ADDENDUM NO. 1 TO PROJECT NO. 44329

**REPLACE WINDOWS,
SOUTH HALL AND B-3 HOUSING
EASTERN CORRECTIONAL FACILITY
INSTITUTION ROAD, PO BOX 338
NAPANOCH, NY 12458**

March 1, 2013

DWG NO: SK-1

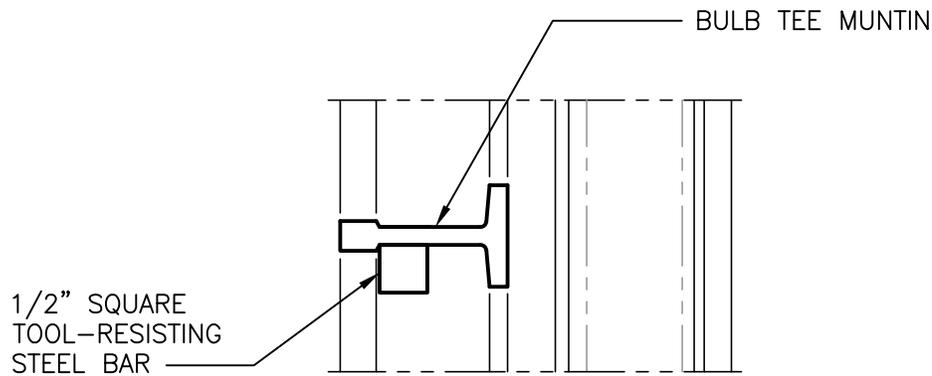
- a. Detail 7: Delete detail in its entirety.
 - b. Detail 8: Change note “CUT/REMOVE TOOL RESISTANT SECURITY BARS. CUT EXISTING MOUNTING BRACKETS AND GRIND FLUSH WITH EXISTING MASONRY WALL. PAINT REMAINING EXPOSED STEEL WITH ESP PRIMER AND IAL-3 PAINT (TO MATCH EXISTING).” to “TOOL RESISTANT SECURITY BARS TO REMAIN. PAINT WITH IAL-3 PAINT”.
15. Drawing A-504:
- a. Wall Section 3: Delete wall section in its entirety.
16. Drawing A-506:
- a. Detail 8: Delete detail in its entirety.
 - b. Detail 10: To note “EXISTING BASEMENT SECURITY BARS TO REMAIN, PROVIDE TYPE ESP PRIMER AND EAL-3 PAINT” Add “REMOVE EXISTING EXPANDED METAL SCREEN FROM EXTERIOR OF BARS. PAINT BOTH THE BARS AND EXPANDED METAL SCREEN WITH ESP PRIMER AND EAL-3 PAINT AND REINSTALL EXPANDED METAL SCREEN”.
17. Add Drawing SK-1 (attached) to construction documents.
